Botley West Solar Farm Ref: EN010147 - Deadline 1: June 4th 2025
For the attention of the Planning Inspectorate. Our reference number: RR 0413

Botley West Solar Farm: Written Representations, absorbing information from earlier submissions, accompanying ICOMOS-UK's Registration as an Interested Party, including a Summary and overlays on the Applicant's 'Botley West Solar Farm Preliminary Masterplans'.

These comments and Masterplan overlays are from the Cultural Landscapes and Historic Gardens Committee of ICOMOS-UK.

ICOMOS-UK CLHGC
AREAS UNSUITABLE FOR INCLUSION
IN ANY SOLAR FARM (overlaid green)
Botley West Solar Farm
Preliminary Masterplan
- North (section 1 of 2)

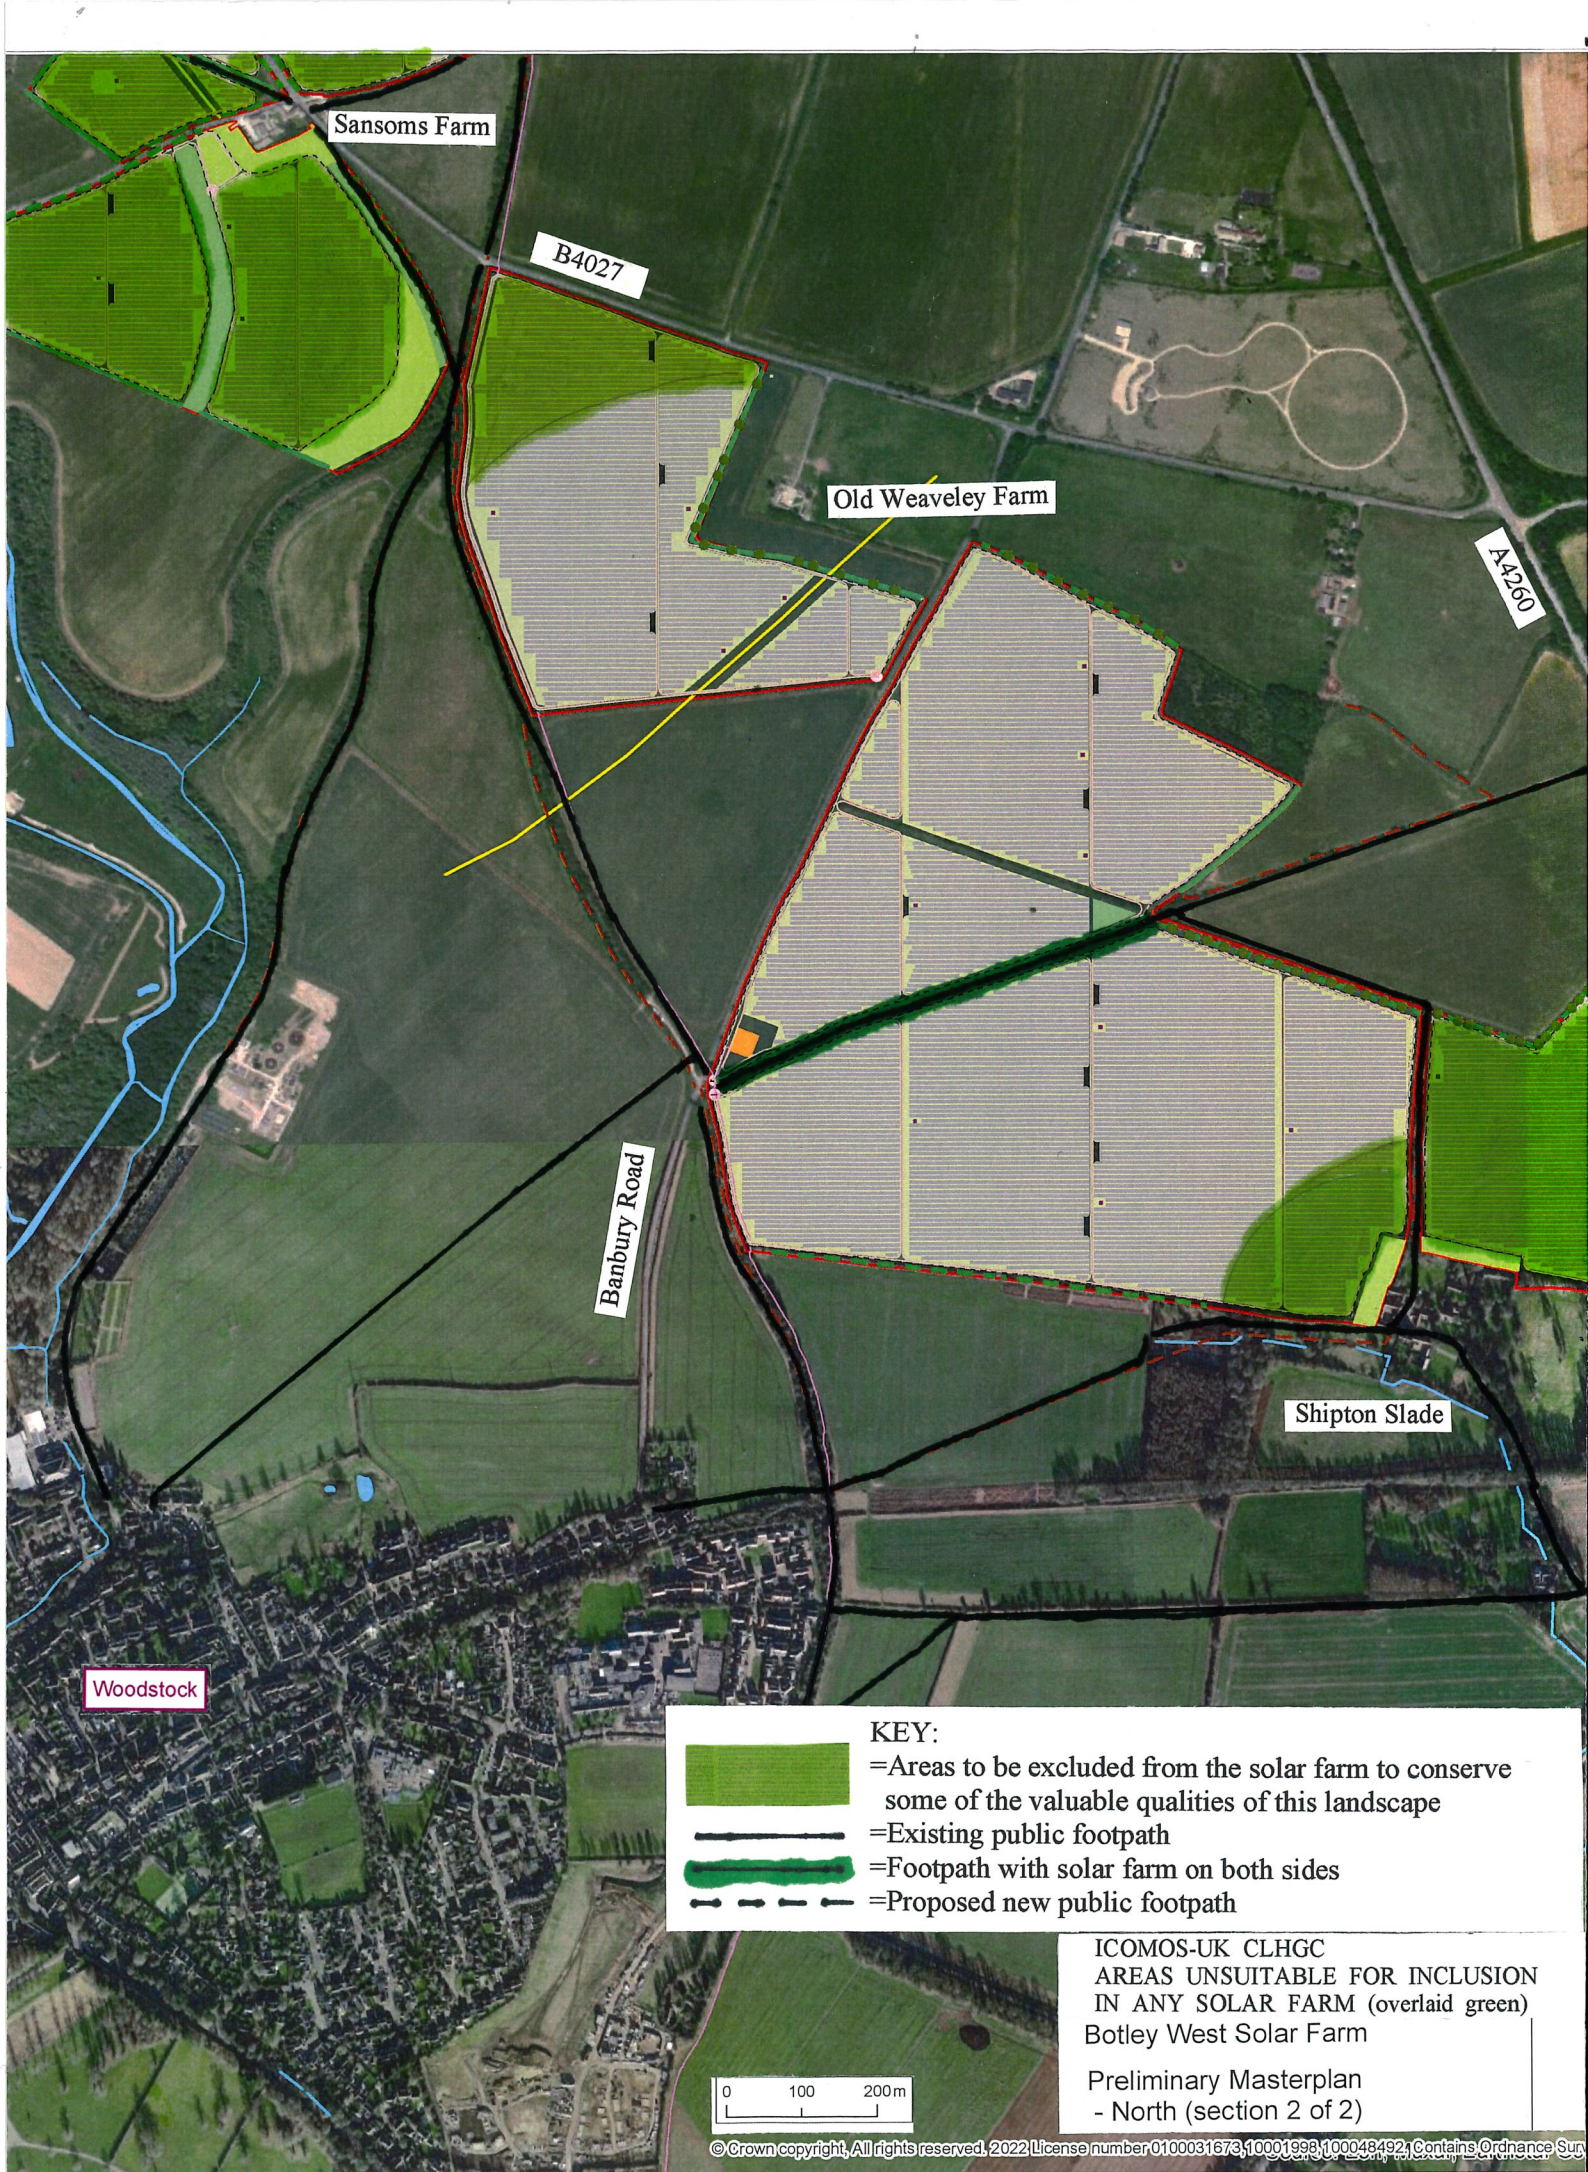
An exception to this is around Hordley and Sansoms farms, near the B4027 road and several public footpaths including 'Oxfordshire Way' along Akeman Street. Here the land is dome shaped and visibly sloping. Therefore, **the southern bays on Masterplan-North Section 1 [1.11 south half; 1.12] and northwestern bays on Masterplan-North Section 2 should be omitted [1.13; 1.14 northern quarter].**
